2006 Toyota Tundra 4.7L Eng SR5

M.I.L. "ON" DTC P0335 AND/OR P1340: INTERMITTENT HOT SOAK NO-START

TECHNICAL SERVICE BULLETIN

Reference Number(s): EG052-06, Date of Issue: August 24, 2006

Fig 1: Identifying Camshaft Position Sensor Components

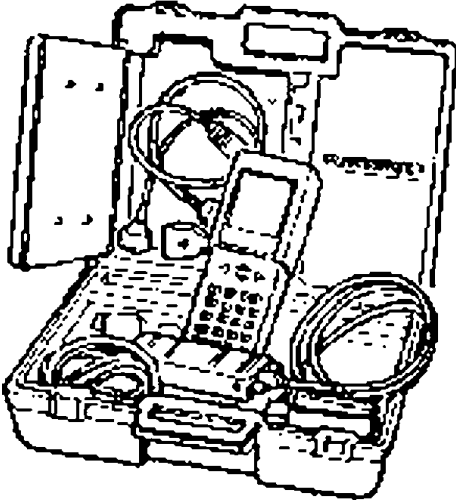
Some customers may experience a M.I.L. "ON" condition with DTCs P0335 and/or P1340 with intermittent hot soak no-start. The camshaft position sensor assembly has been improved to prevent this concern.

PREVIOUS PART NUMBER	CURRENT PART NUMBER	PART NAME	QTY
19300-50010	19300-50030	Camshaft Position Sensor Assembly	1

3. Replace the camshaft position sensor .
4. Using the Diagnostic Tester, clear the DTCs.
5. Test drive the vehicle for a minimum of 10 minutes. Then use the Diagnostic Tester to verify that NO pending DTCs set.
